HUDDERSFIELD

DESIGN & ACCESS STATEMENT ADDENDUM

SEPTEMBER 2024

Fig. 6.1.10 Proposed Amended Plan - Level 02 Floor Plan

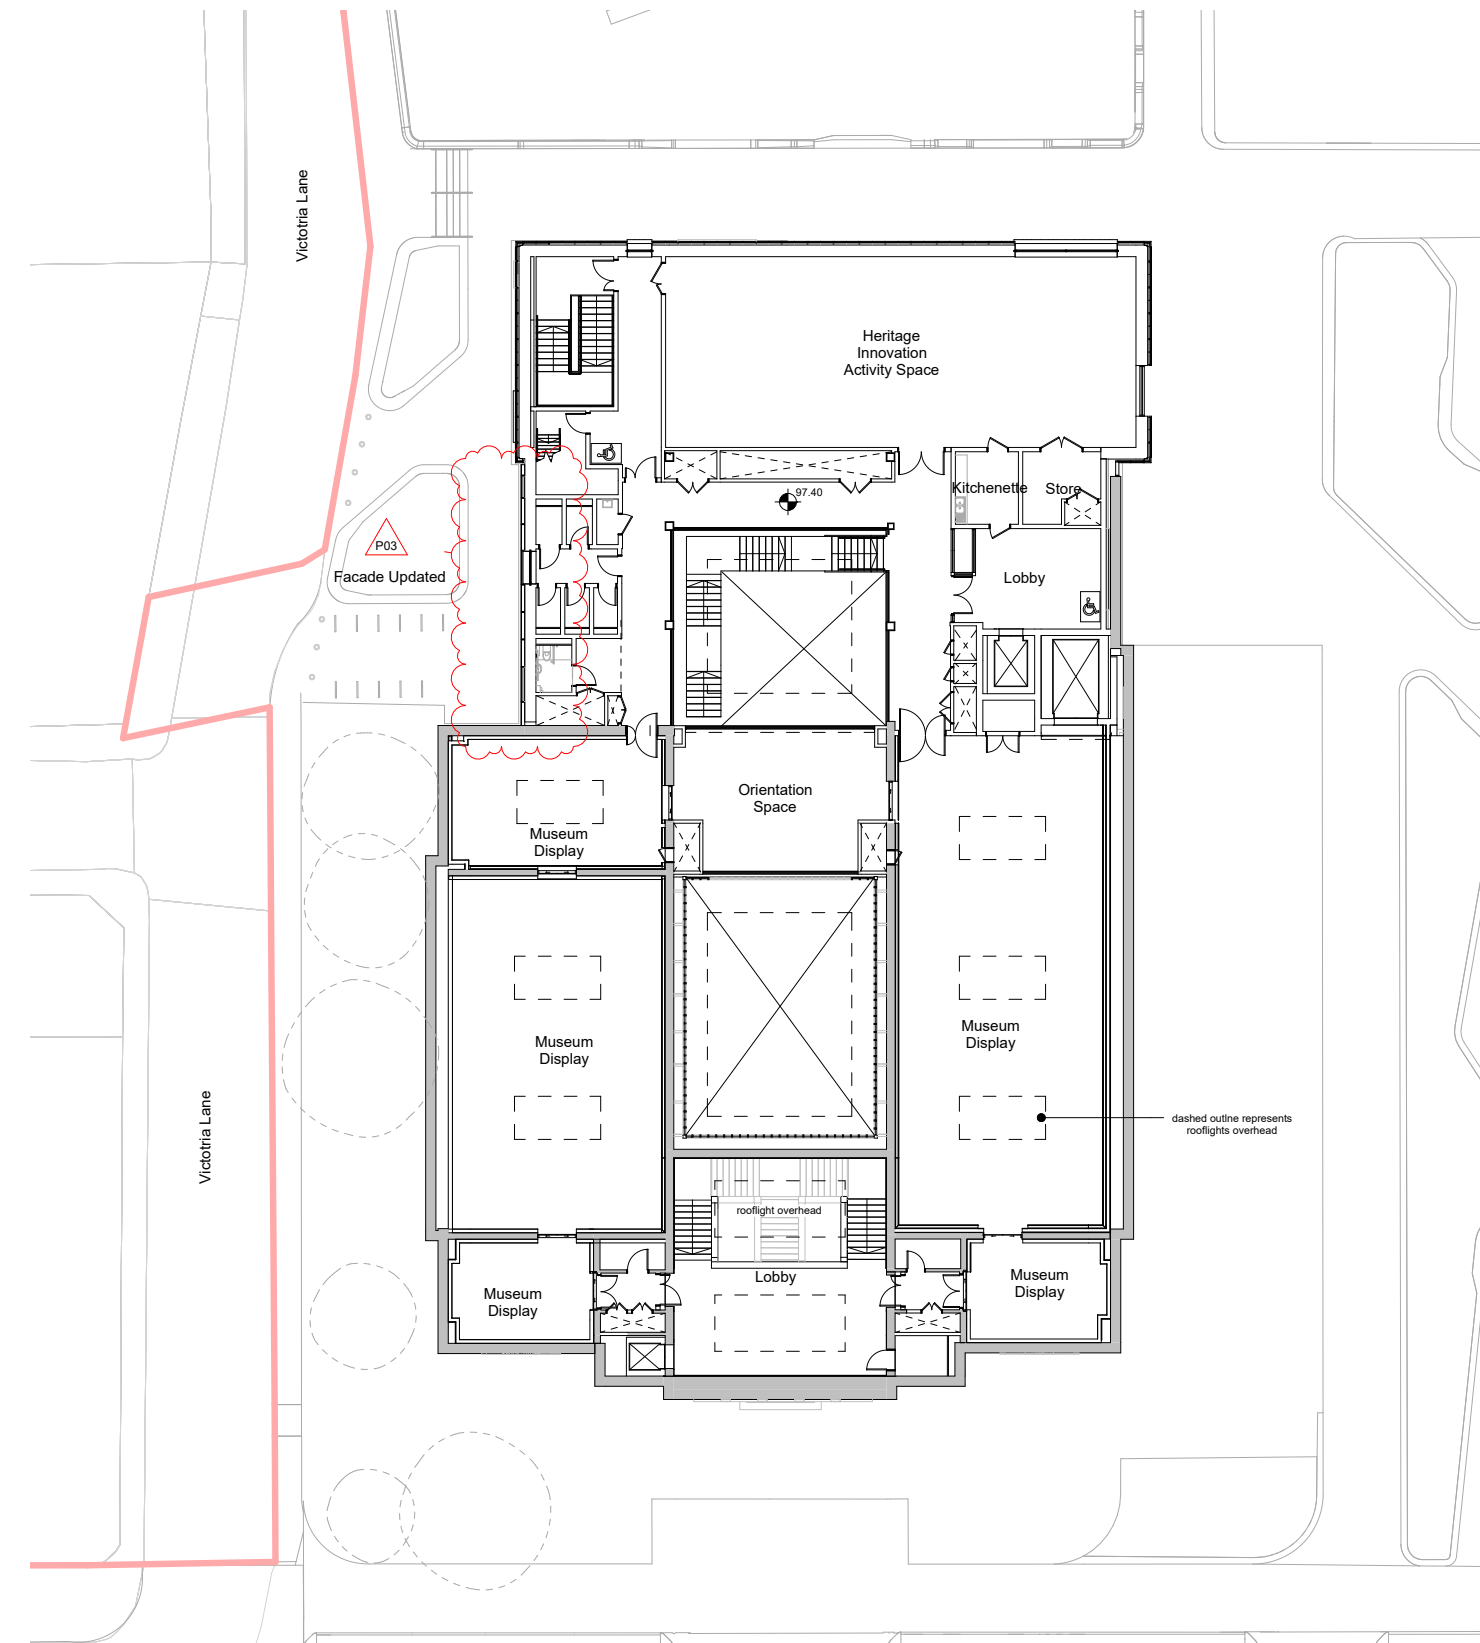
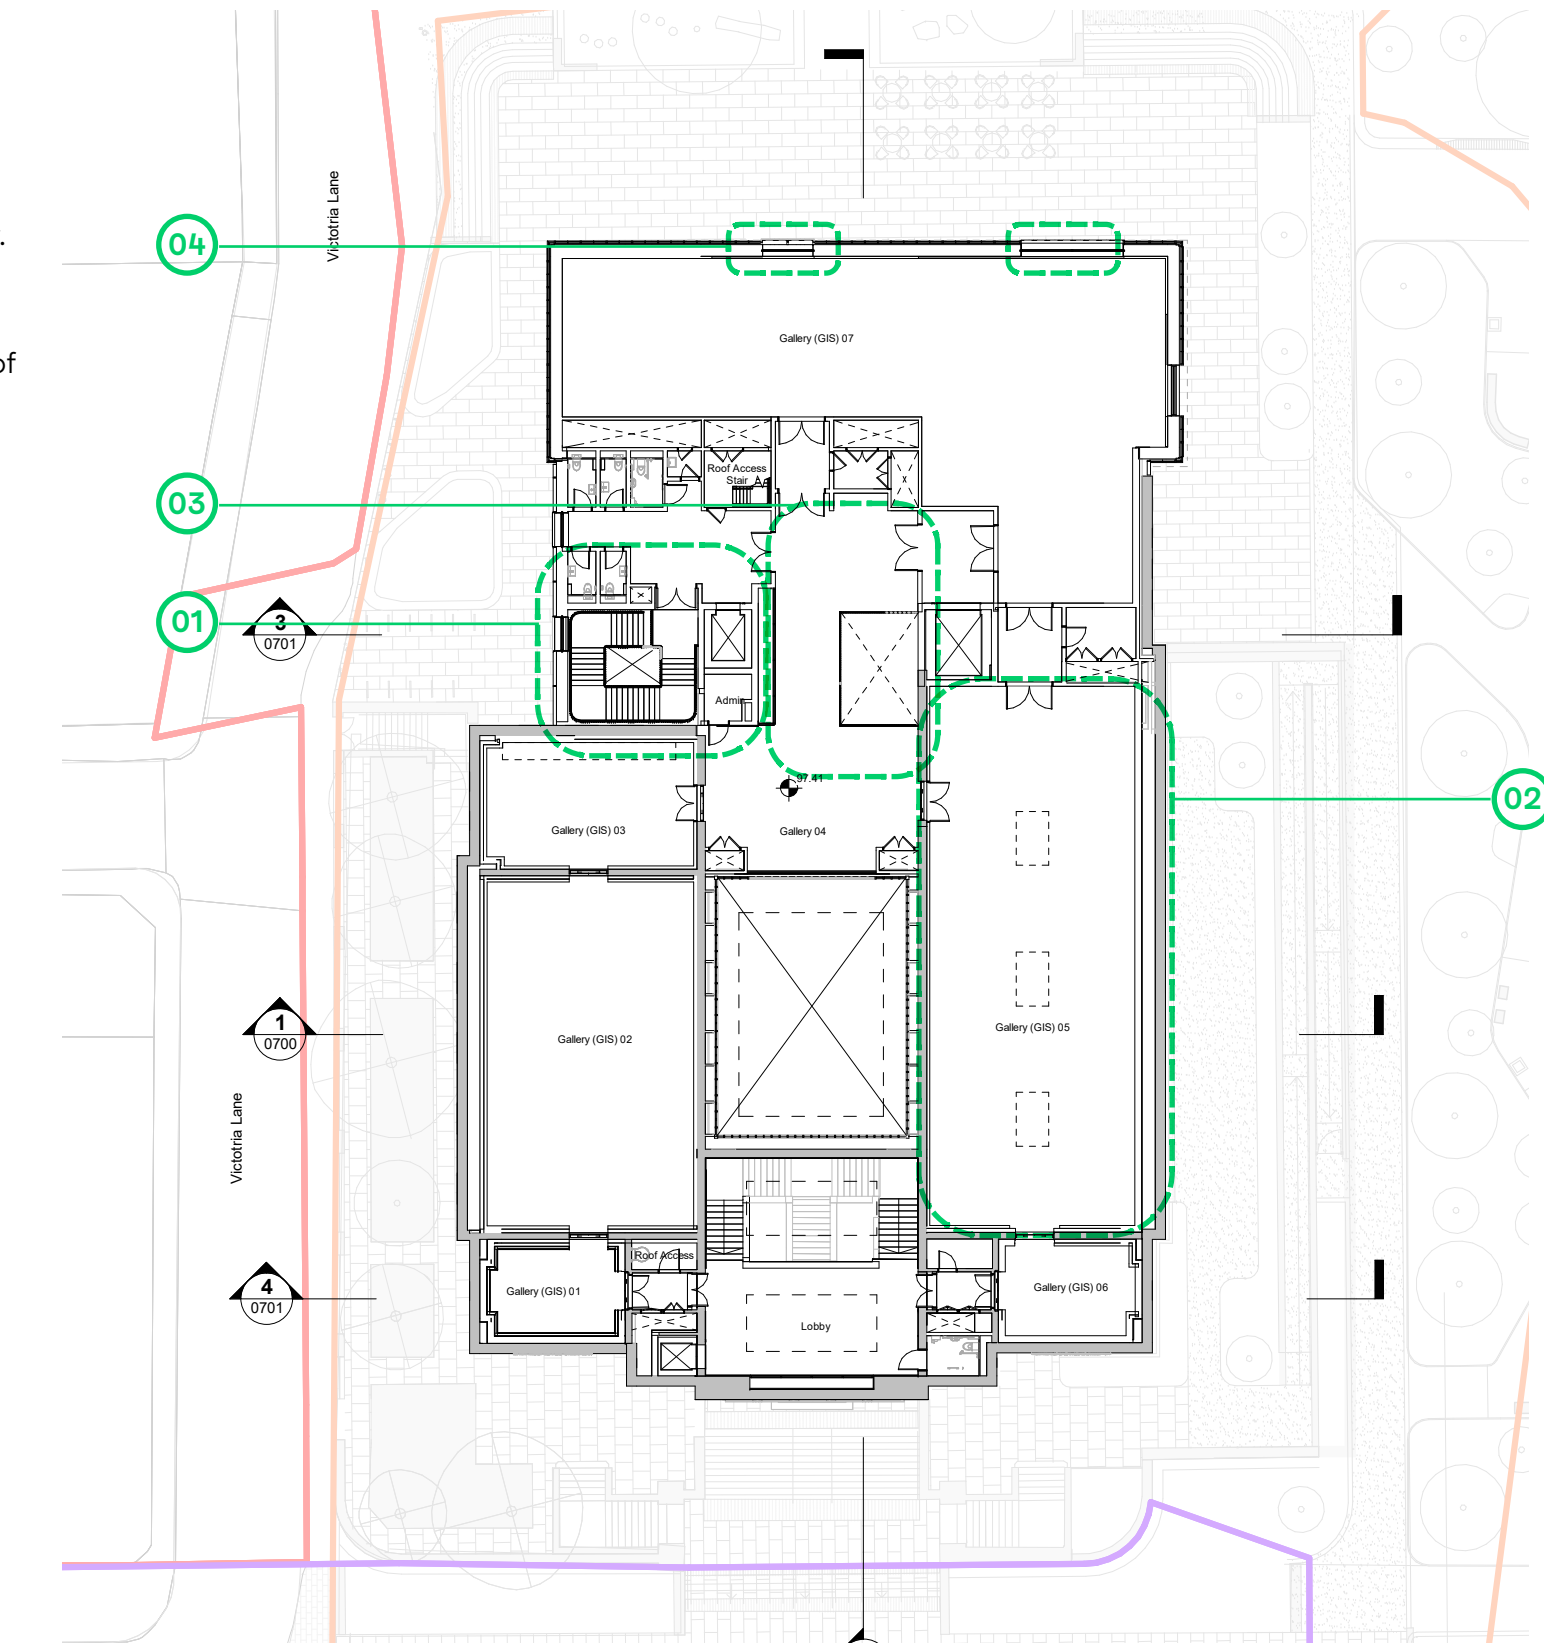
- 01 Rationalisation and relocation of stair core and lifts. Changes reduce intervention to existing North facade.
- 02 Amendments to existing east facade enables existing room extents to be retained and used as Museum Display.
- 03 Feature stair omitted and new atrium design to provide addition area for museum and art gallery display whilst providing visibility and good user flow between floors. Roof light above amended to suit new design.
- 04 Window locations of new extension updated to align with internal layout changes.

Fig. 6.1.12 Proposed Amended Plan - Roof Plan

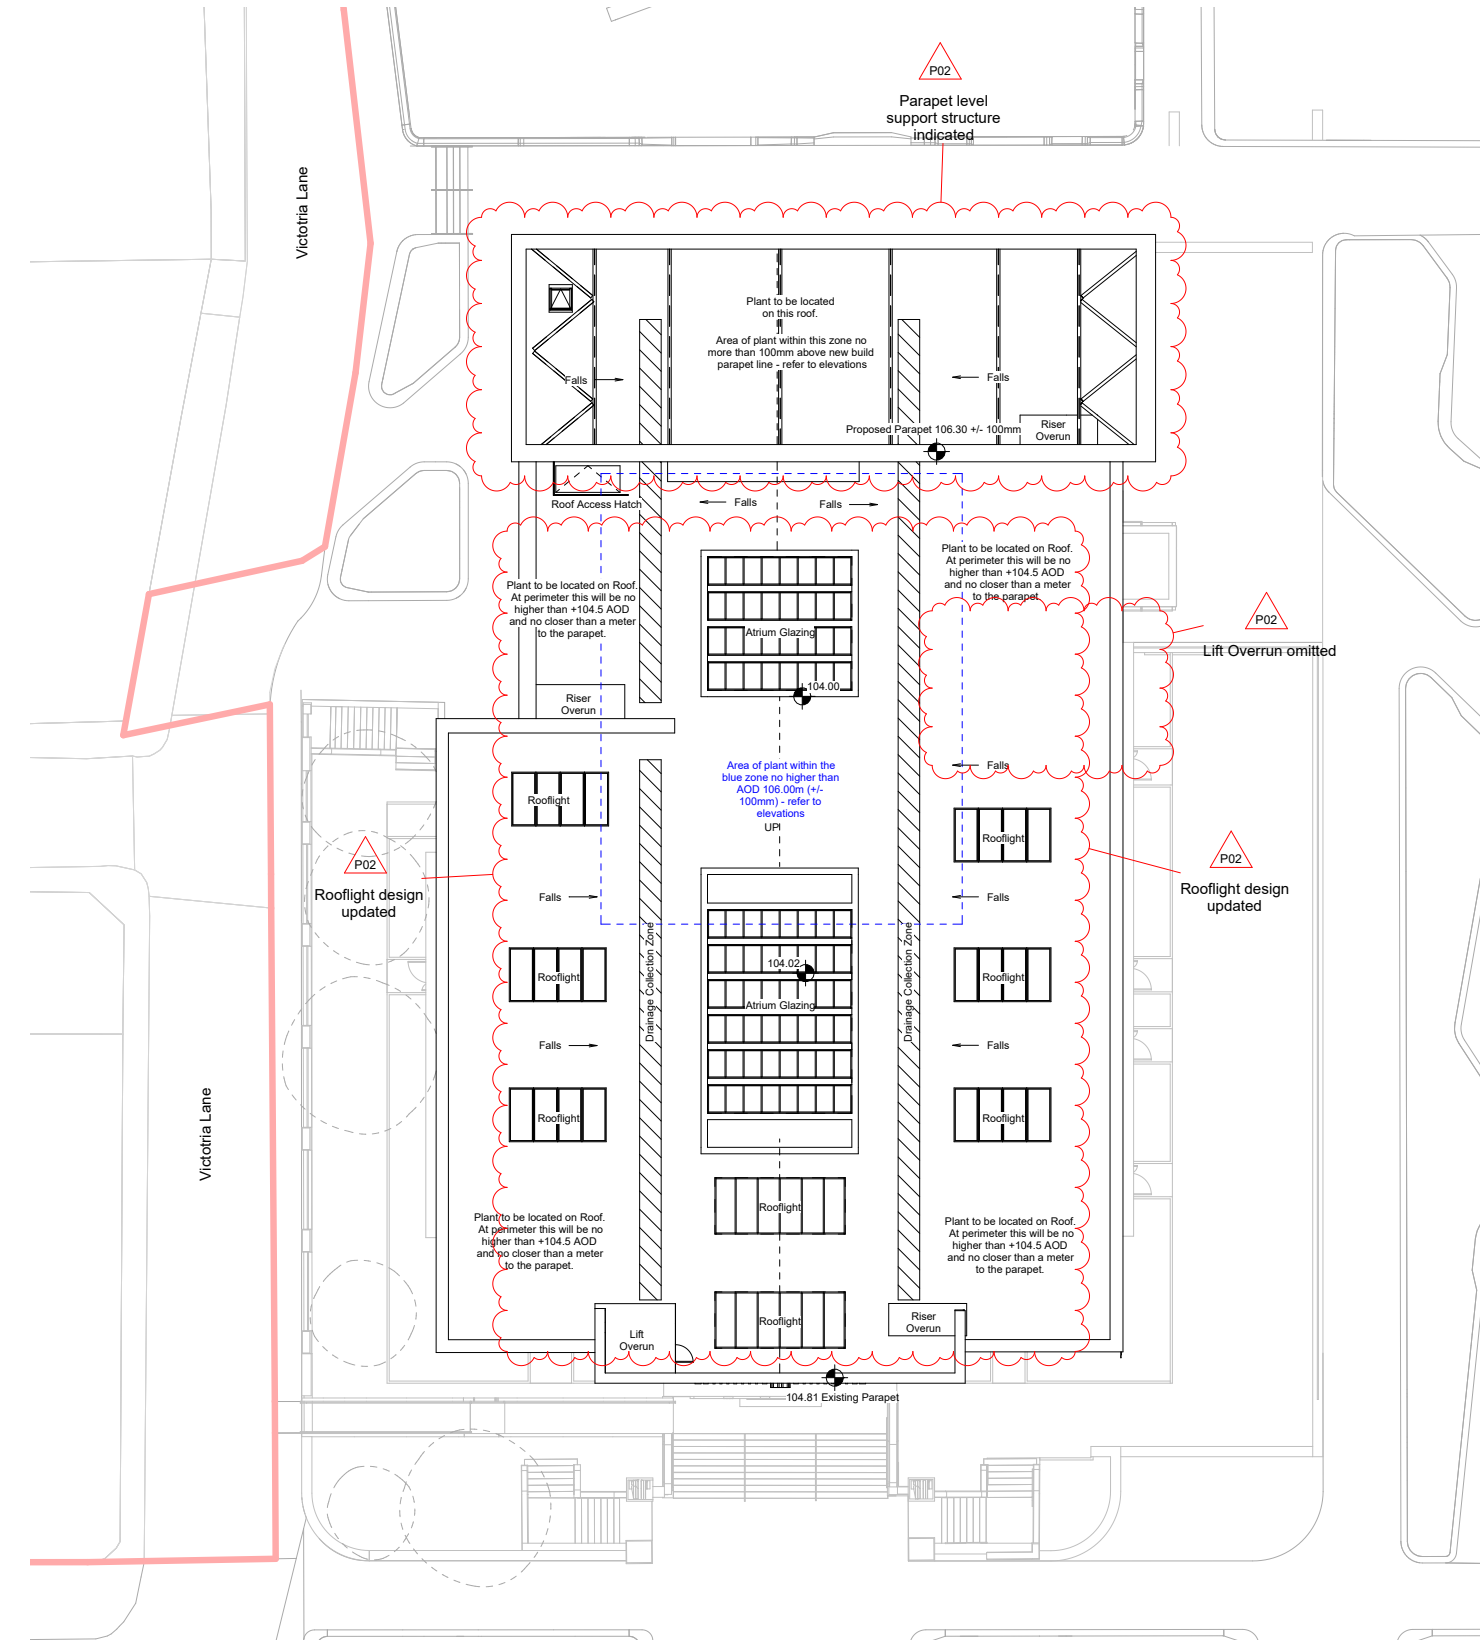
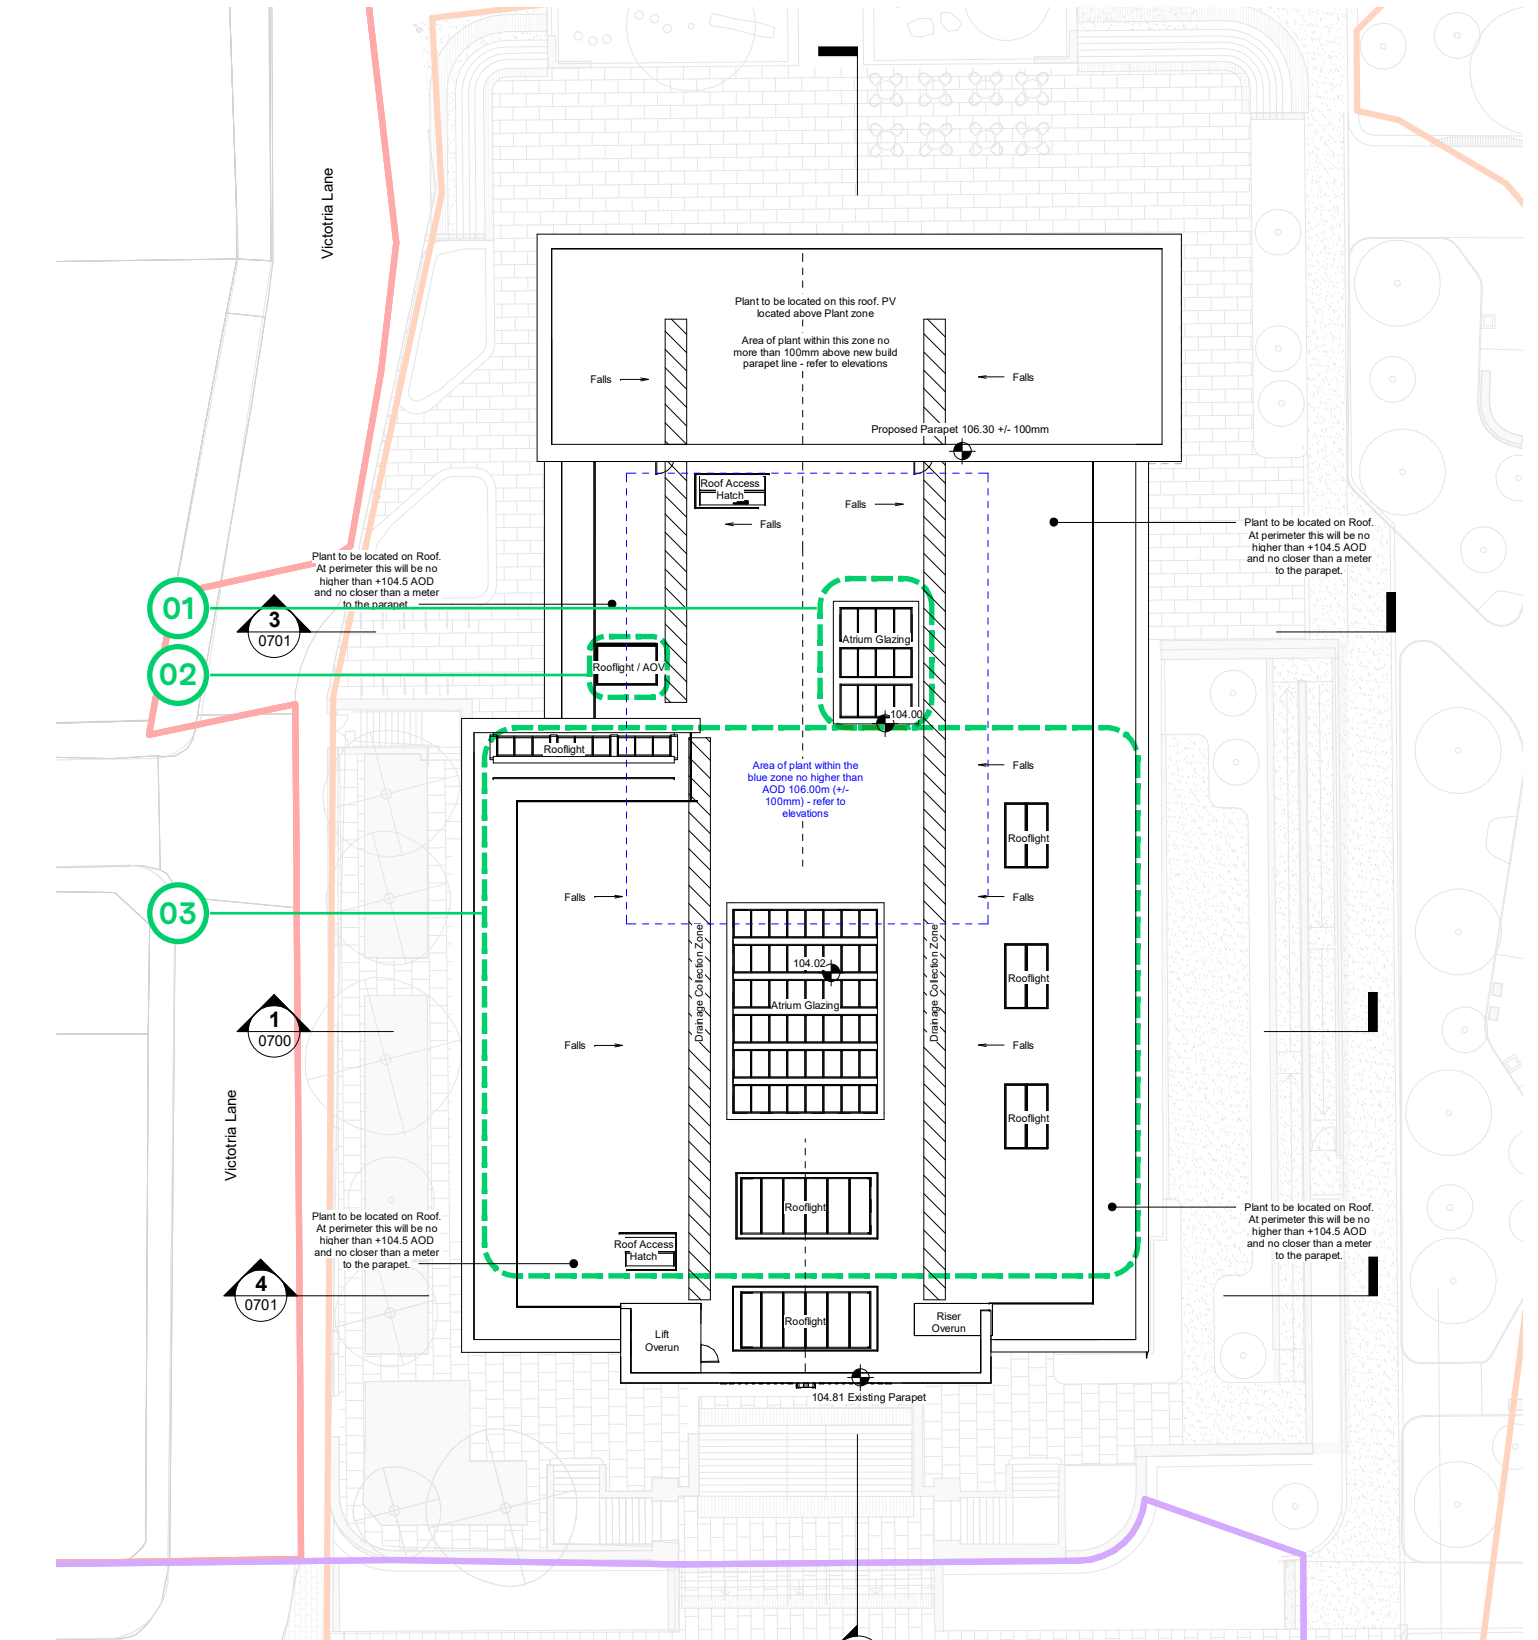
- 01 Rooflight arrangement updated in line with atrium amendments.
- 02 Additional roof light above new western stair.
- 03 Roof lights rationalised to suit Art Gallery requirements.
